Inaccuracies of HS2 noise calculations and model

Summary

This paper presents an analysis of the HS2 noise calculation model which shows that there are six significant errors in the methods for calculation of predicted noise and value for money carried out by contractors, as prescribed by HS2 and presented in noise demonstration reports. These errors represent a 8.5dB (or more) under-prediction of night-time L_{Amax} noise in excess of LOAEL affecting Wendover.

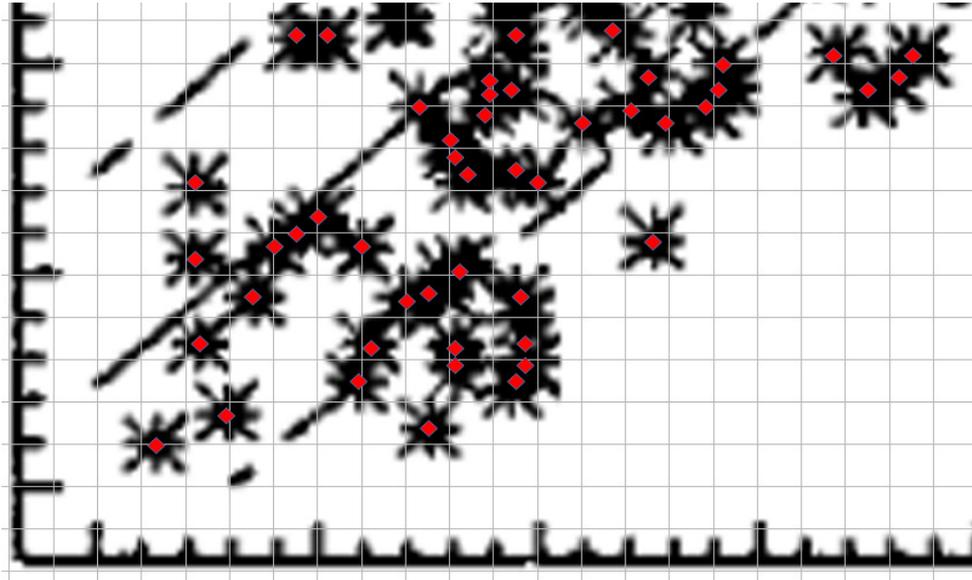
Wendover HS2 had observed that in the highlighted area (below 71dB calculated), the observed figures appeared to be higher than calculated. This is the range which affects almost all receptors in Wendover which are above night-time L_{Amax} LOAEL. The data represented by the points on this chart within the red box were extracted to a table (see Appendix A). There were 48 data points which provides a sufficiently large sample for this analysis.

To verify that this has been done with sufficient accuracy, a scatter chart was superimposed on the original HS2 chart, to position the points in the centre of the stars on the original, as shown below:

The mean difference between measured and calculated values was 2.06 dB. To assess the significance of this it is necessary to look at the standard error of the mean difference. The standard error of the model is 3dB but this relates to a single observation rather than a group of observations. The standard error of the mean is obtained by dividing this by $\sqrt{(48-1)}$ giving 0.44. Based on this, the probability that the true mean difference is zero or less is 0.00013%, which is vanishingly small.

The conclusion from this is that the HS2 noise model is not valid in this data range below 71dB. It can be corrected by the addition of a 2dB adjustment.

The ES also provide charts representing data from a measurement campaign carried out in 1989 – 1990 on the TGV Atlantique route in France. TGV-A high speed trains were running at nominal speeds of 300kph on flat ground. Annex D2 Figure 18 is shown below:

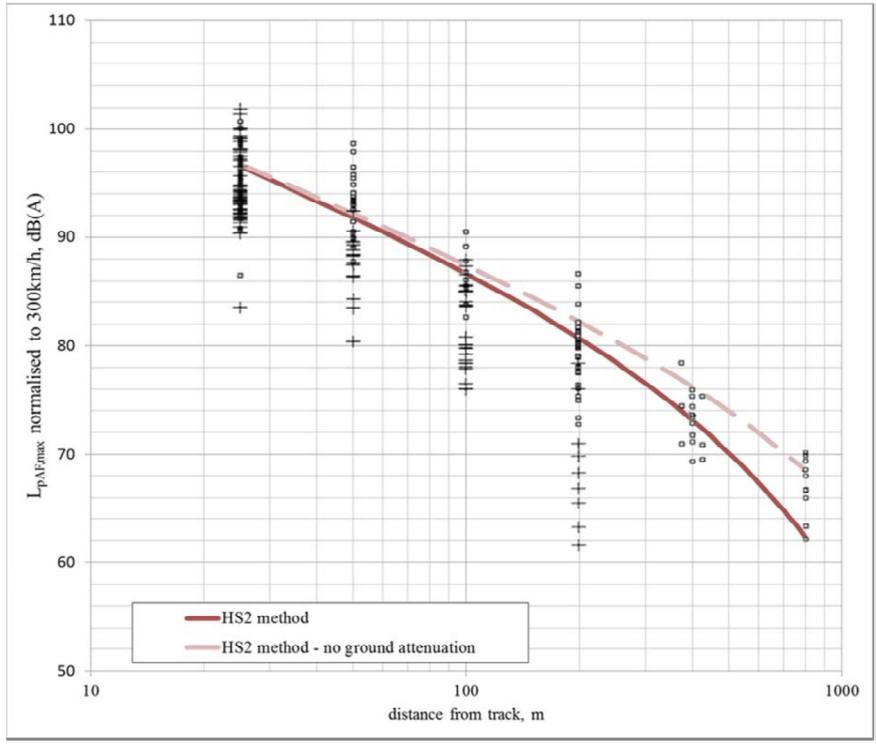
The rectangles represent downwind conditions and the crosses upwind conditions. The lower line represents the HS2 model, which is valid for downwind conditions. It will be seen that for the lowest group of points (800m), in the range up to 70dB, the measured results are consistently above the calculated results and the average difference is 2.5dB. This set of data would therefore confirm the finding from the AEL Paper that there is a consistent error of around this magnitude.

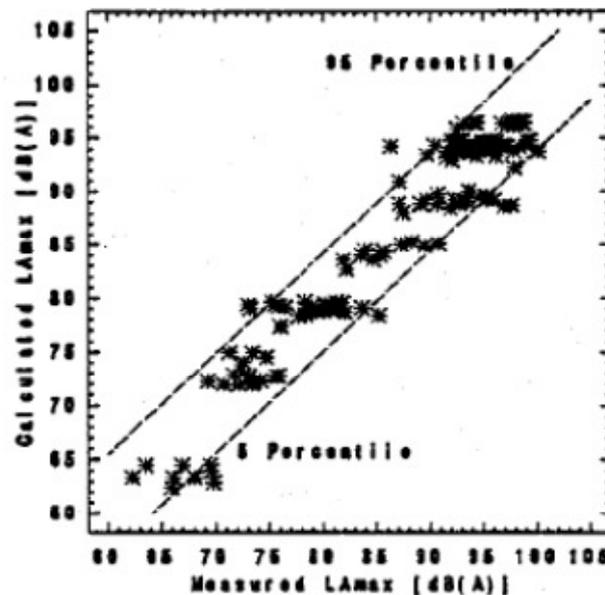
- If any preliminary grouping of data had taken place, one would expect this to have been mentioned as part of the description of the methodology. The process would have required some manipulation of the data, as the speeds of individual trains would have varied, and it would be unusual to have grouped data in this way without mentioning it.
- The data in the AEL paper and shown in the graph reproduced above was used in a multiple regression analysis. It would be most unusual for this not to be done on the actual observed data points.
- It is clear from the description in the ES relating to the TGV data that each point represents an individual passby, and the ES comments that “at a given distance from the track, the measured data is characterized by a large spread” which is evident from the chart.
- The AEL Paper has a corresponding graph representing flat ground:

Although the axes are reversed, the distribution is similar to the TGV chart, and as with the TGV chart shows six clusters of data. The vertical axis shows calculated rather than distance, but as this is the flat ground model, distance is the only independent variable in the HS2 model and so one can conclude that as with the TGV data, each cluster represents individual observations at a given distance. Again a similar wide spread of measured results is observed (only the downwind observations are shown here).

Hence, it is reasonable to conclude that the **standard deviation of the noise from individual passby events** in downwind conditions is close to the **model standard error of $\pm 3\text{dB}$** .
